Statement of Basis Approval of No Further Action Volume 2 of 30 January 2000 ER Site 23 Operable Unit 1309 Round 2

**ER Site 23
Operable Unit 1309
Round 2**

**Statement of Basis
Approval of No Further Action**

NOD Originally Submitted October 1996

Figure 1. Disposal Trenches Site 23

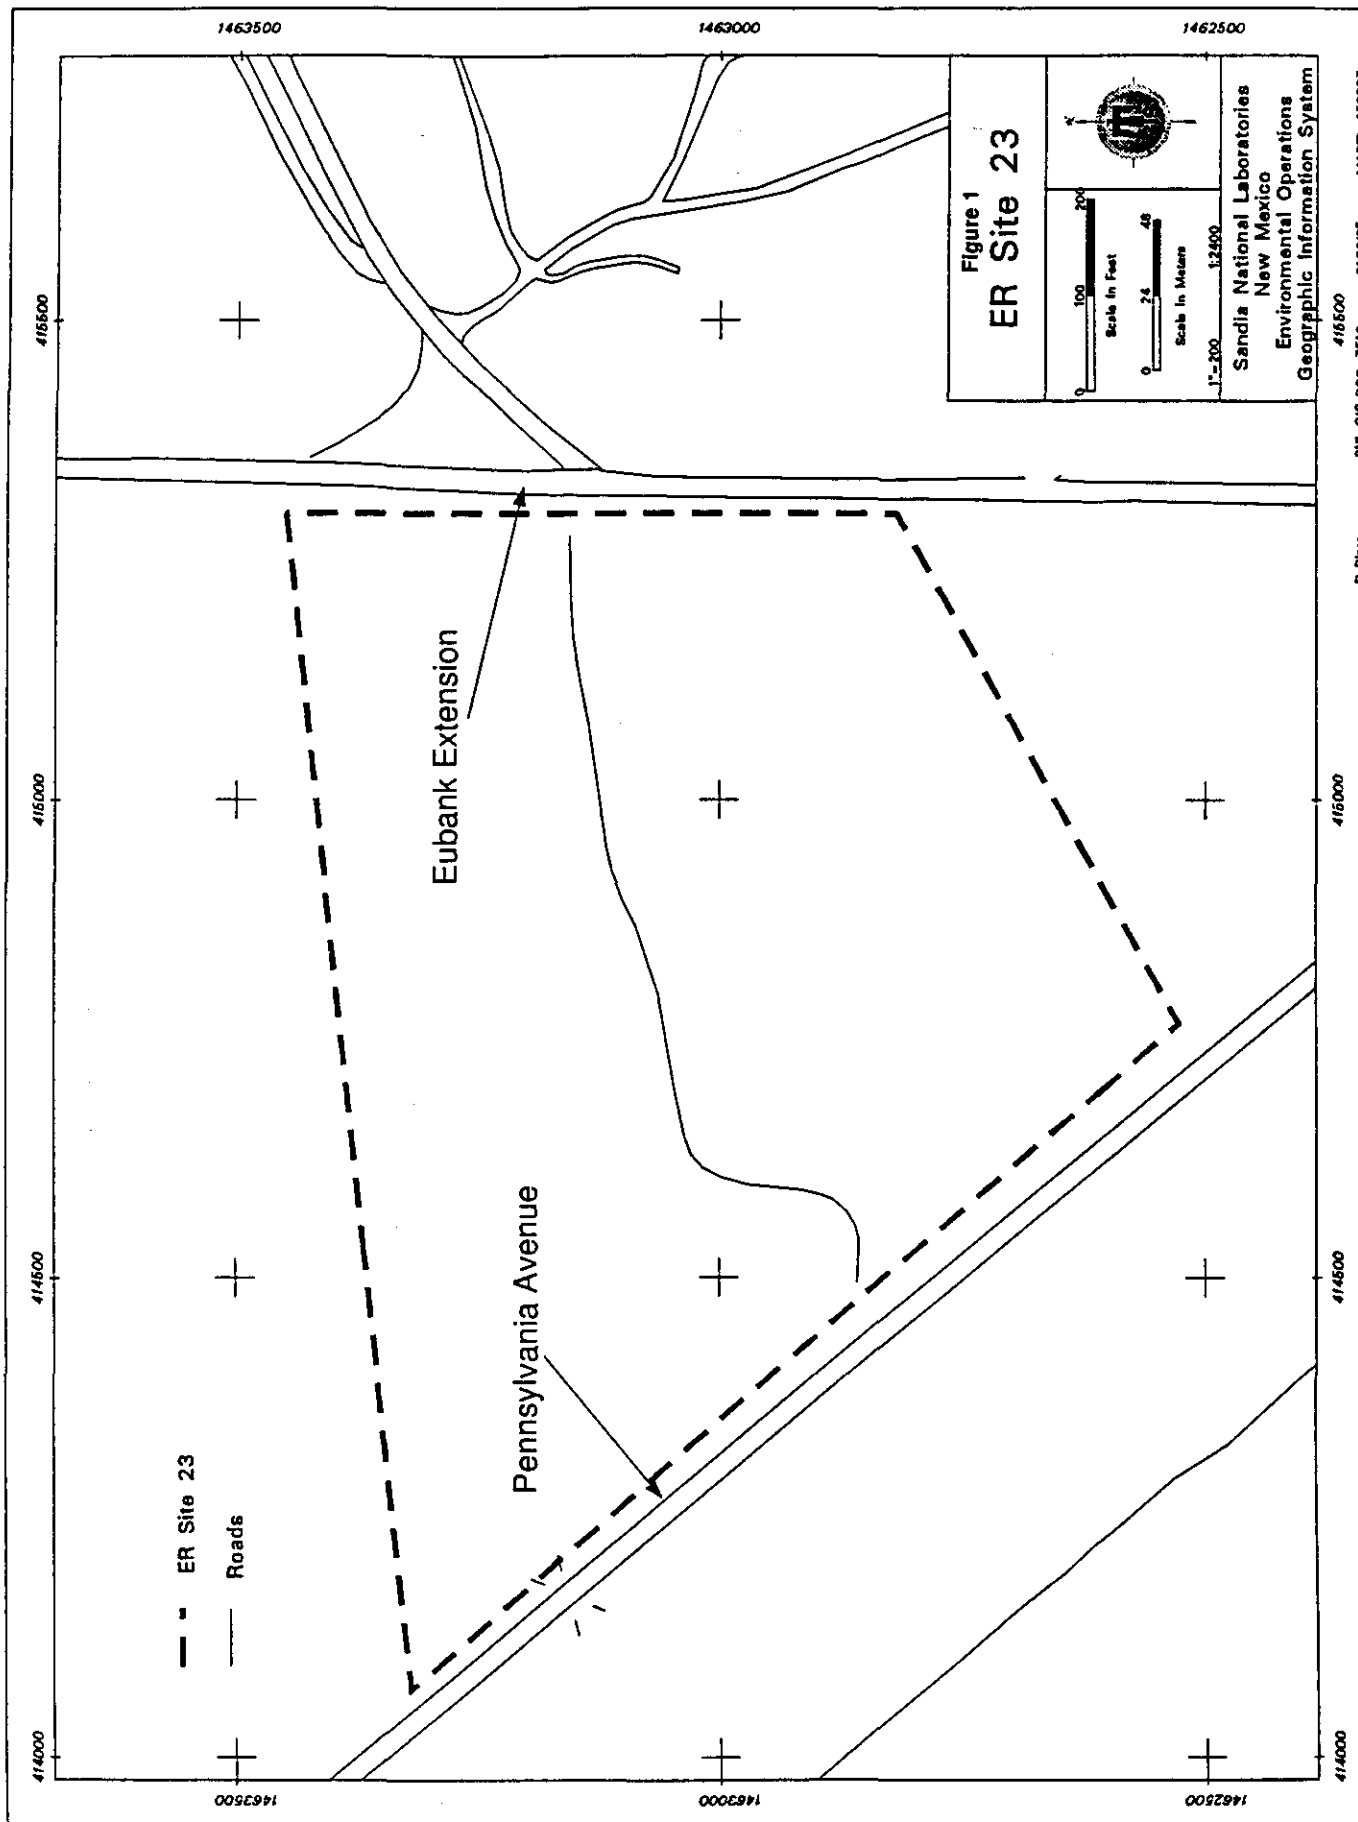
c. **The map showing ER Site 23 does not show enough information to easily locate the site on the ground. Please provide a more complete map.**

Response: A more useful figure is attached as Figure 2. The site is located near the junction of Pennsylvania and Powerline (Eubank Extension) roads.

Figure 3
ADS 1309
Locations of Trenches
within ER Site 23

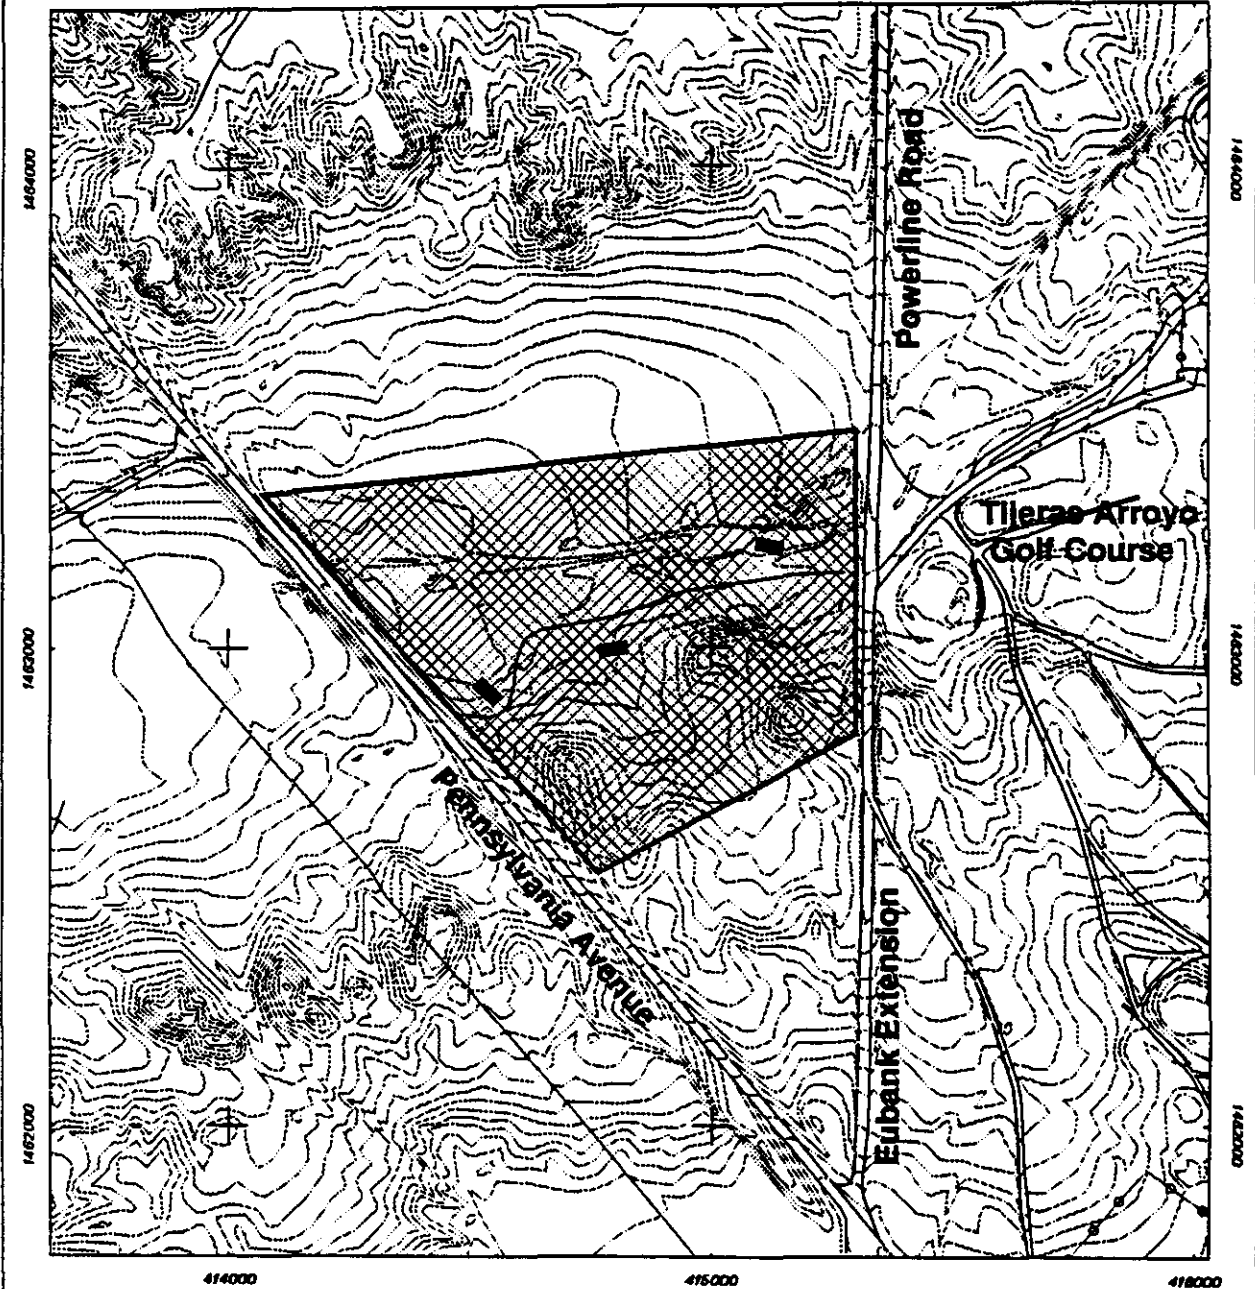
a. Unless additional information (e.g., which isotope of thorium, other radioactive materials, size and distribution of sources) becomes available, a more thorough and areally expanded radiation survey should be conducted.

SNL/NM has already conducted an exhaustive (100%-coverage) radiological survey in the 'staked area' that was believed by the interviewee to be marked by faded-yellow, metal posts (Figure 3). The survey was conducted in 1994 as part of the ongoing Sandia Surface Radiological Survey project. A team of radiological technicians used Crutch Gamma Scintillometers to sweep a 100 ft by 100 ft grid surrounding each suspected trench location. Each Crutch Gamma Scintillometer was constructed of a Mount Sopris portable gamma scintillometer

Figure 4. Excerpt of KAFB engineering map depicting the Sanitary-Sewer System and the Defense Nuclear Agency training sites (TS) in the vicinity of ER Site 23. [The 'ER Site 23' label was added by the SNL/NM ER Project.]

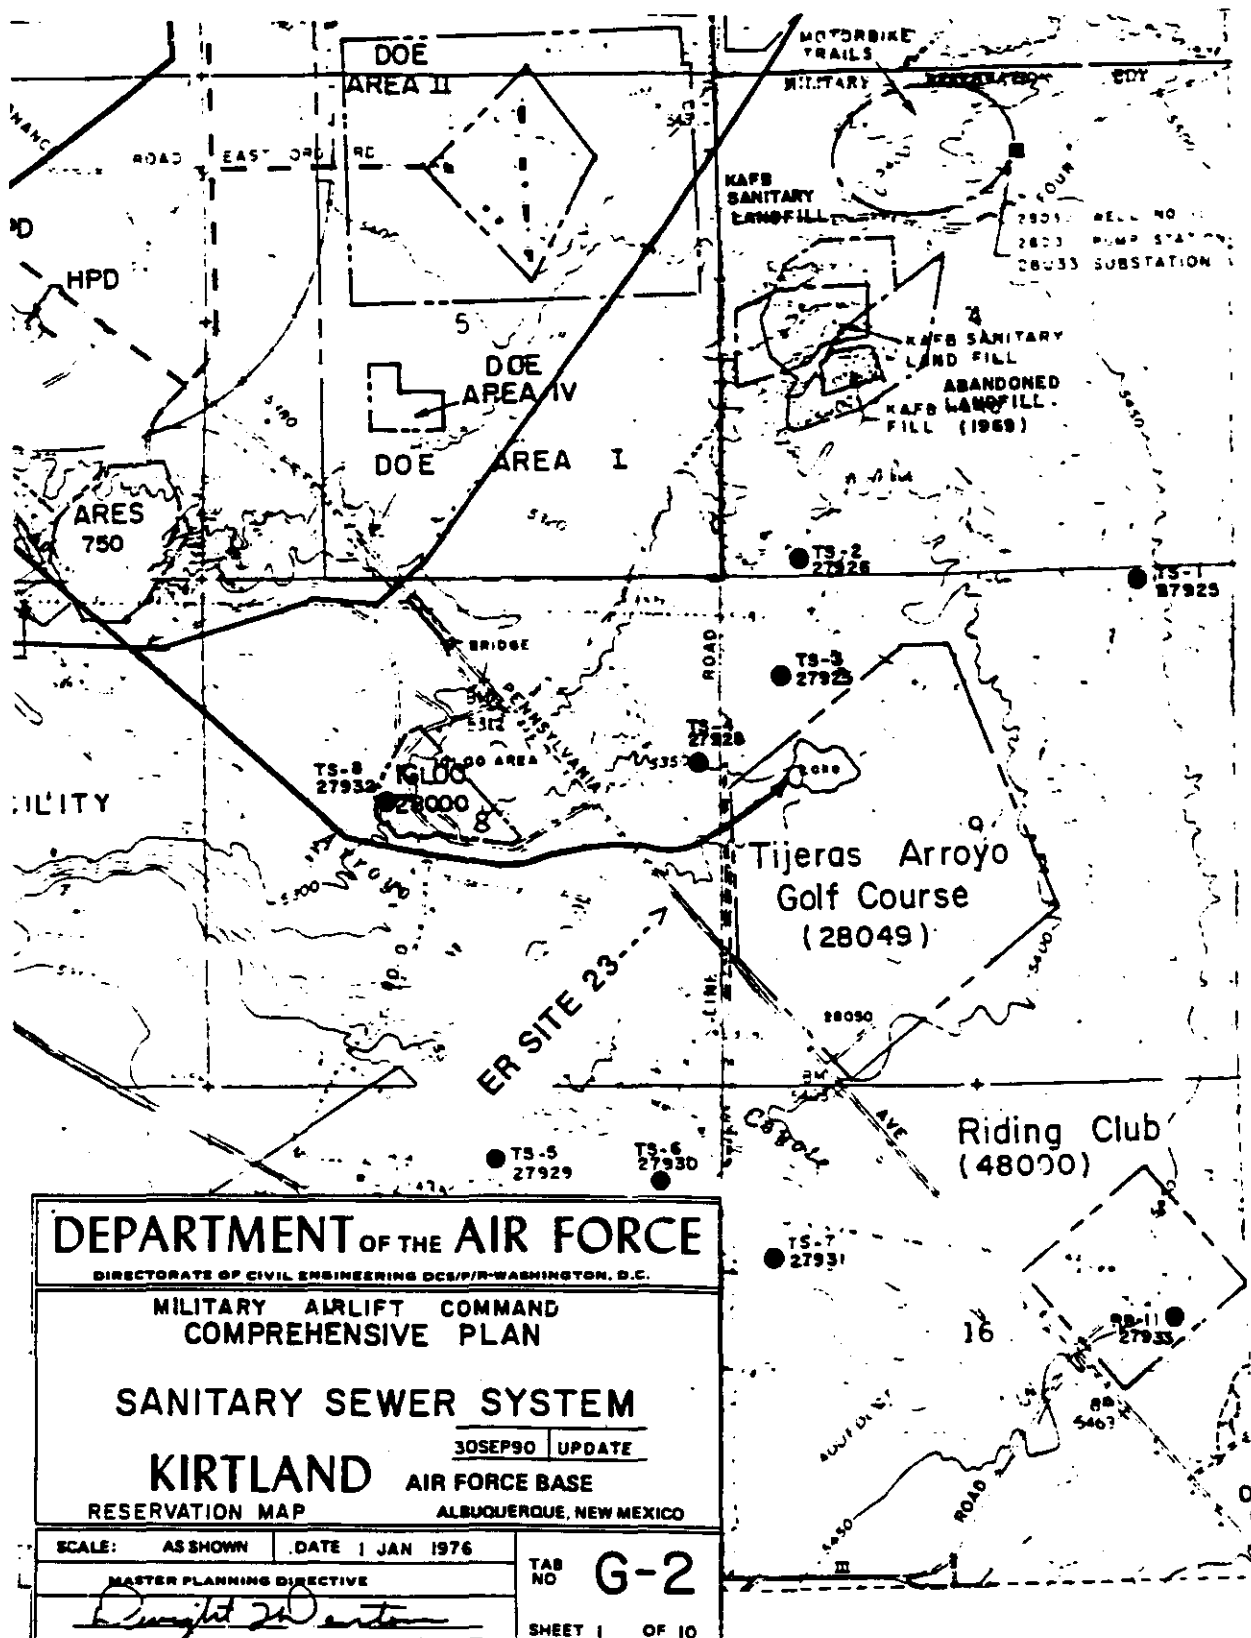
b. The proposal lacks sufficient detail concerning the results of the surface geophysical survey. Where was the detected water line located? The electromagnetic survey may have been impaired by the abundant power lines and utilities that cross the site. Another geophysical survey (e.g. ground penetrating radar) might be more appropriate to locate the alleged trenches of Site 23.

Instead of being markers for the suspected DNA-training trenches, the faded-yellow posts are apparently markers for utilities such as buried water lines and telephone cables. Figures 4 and 5 are excerpts of 1976 to 1990 vintage KAFB maps that depict the U.S. Air Force sanitary-sewer and water-supply systems. A sanitary-sewer line and three water-supply lines are shown to cross ER Site 23. Other yellow posts at the site definitely mark a buried water line that is oriented approximately east to west toward a metal building located on the north edge of the Tijeras Arroyo Golf Course (Figure 3). The lack of radioactive or unexplained
